**DECEMBER 12, 2012 SAN DIEGO RWQCB WORKSHOP:**  
**Will tentative storm water regulations be applicable to controlling  
Sunset Cliffs Natural Park erosion and marine pollution?**

DECEMBER 12, 2012 SAN DIEGO R.W.Q.C.B. WORKSHOP  
POSSIBLE AREAS FOR USING LID/BMP APPROACHES FOR CONTROLLING AND USING STORM WATER  
FROM A POINT LOMA NAZARENE UNIVERSITY (PLNU) AND THE SURFRIDER FOUNDATION GRANT PROPOSAL  
AND  
SUNSET CLIFF ASSOCIATION (SCA) DATA

Mr. Lee McEachern  
California Coastal Commission  
Deputy Director, San Diego District  
7575 Metropolitan Drive  
San Diego, CA 92108-4421

October 3, 2012

**FIGURE  
 ES-4**

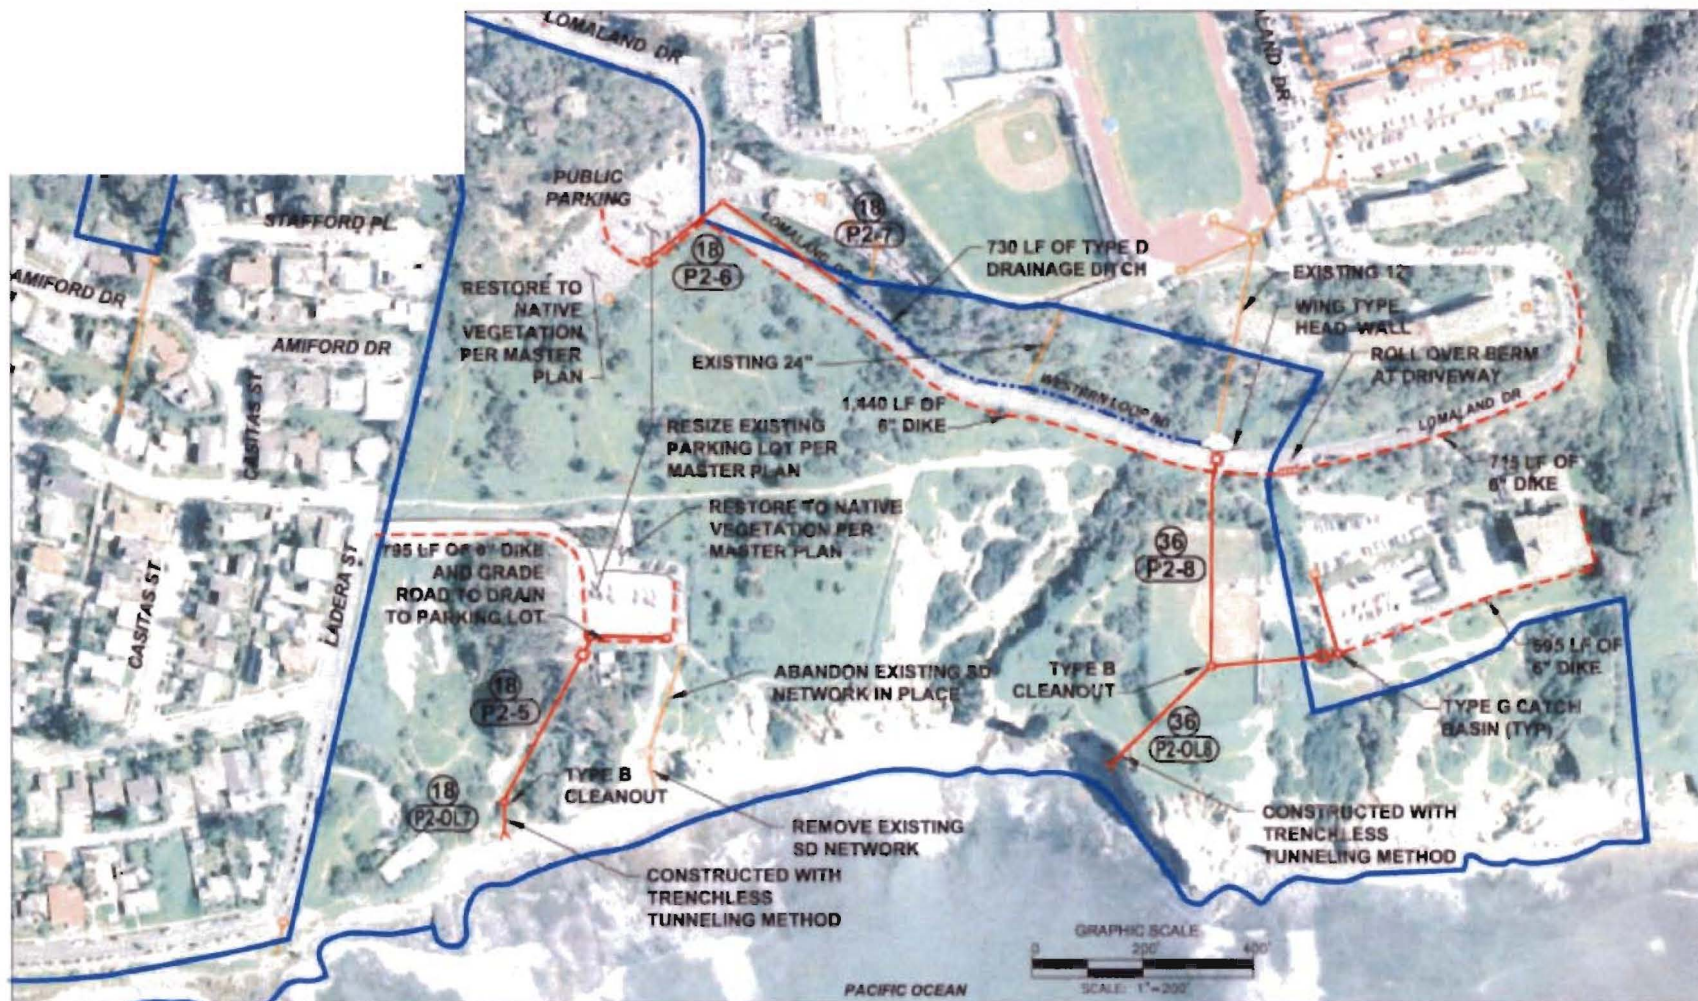
- Will the tentative storm water regulations be relevant to SCNP erosion and marine pollution?
- Where in the planning for SCNP projects, design and construction will the City of San Diego become part of the process for the new storm water regulations?
- How will it be determined if the City of San Diego is or is not in compliance with water quality regulations relative to pollutants and sedimentation in the near shore waters?

The volume of the storm water flow to be anticipated with a fifty-year storm left the design professional for the park drainage plan with no alternative but to design a traditional storm drain system with a big pipe ocean disposal solution to solve the storm water problem.

The big pipe solution itself would have significant impact on the park but, more importantly, it would not protect the ocean from sediment laden runoff discharge into marine waters and habitats.

That is not to say that the PNLU plan 2012 is not better than the PNLU plan 1992, but it nonetheless does not correct future erosion problems, as required by its CUP item 38e. These past current and future problems could be altogether avoided by the application of current standards of care reflected in BMPs, LID, Storm Water Regulations and good engineering practices.

I hope that your group will take a leadership role to get planning and implementation of storm water control measures by PLNU that will eliminate PLNU storm water runoff into the SCNP. Simply put, the 2012 PNLU Drainage Plan should be rejected. PLNU needs a storm water management plan, not a drainage plan. Such a plan would cure future erosion problems and allow the development of a natural park as reflected in the SCNP Master Plan.

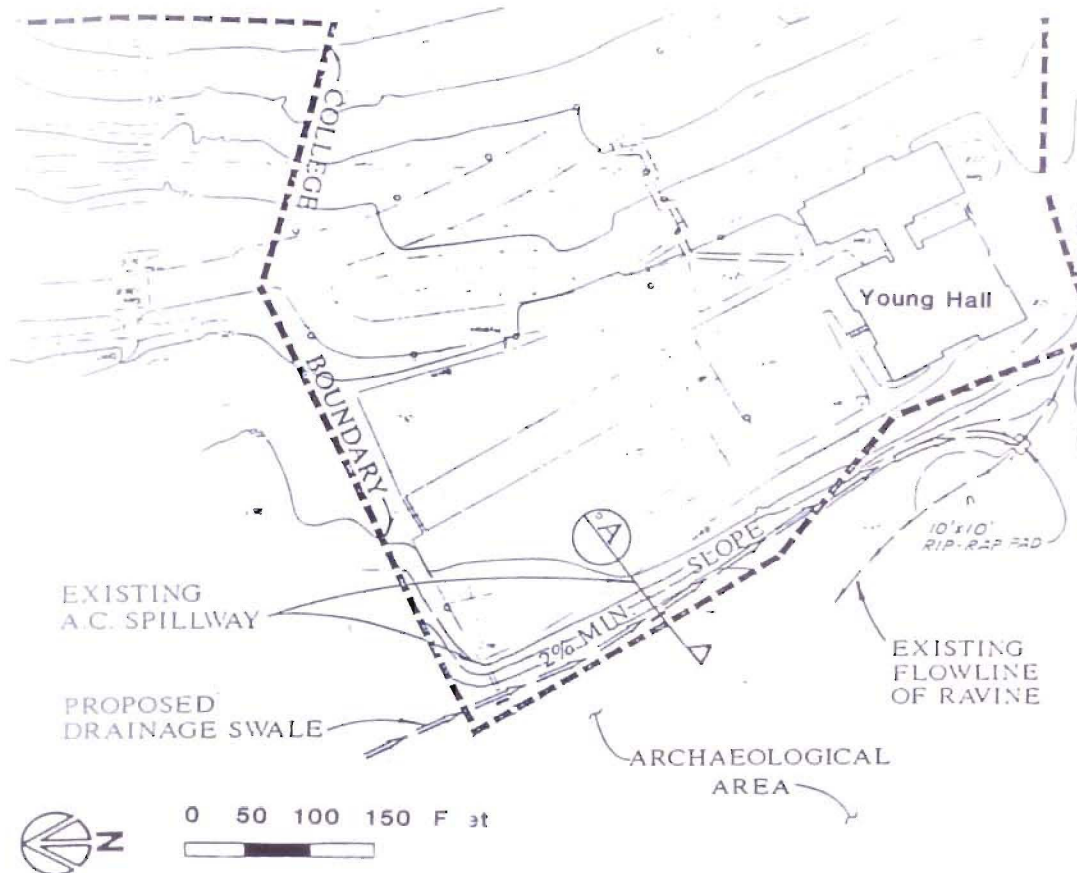
**Figure 4. February 2, 2003 photograph of Culvert Canyon turbid storm water runoff discharges.** This photograph, taken by Craig Barilotti, shows how turbidity due to sediment discharges from Culvert Canyon after being introduced into the coastal waters, moves offshore and alongshore depending on prevailing currents, in this case northward towards Ocean Beach.
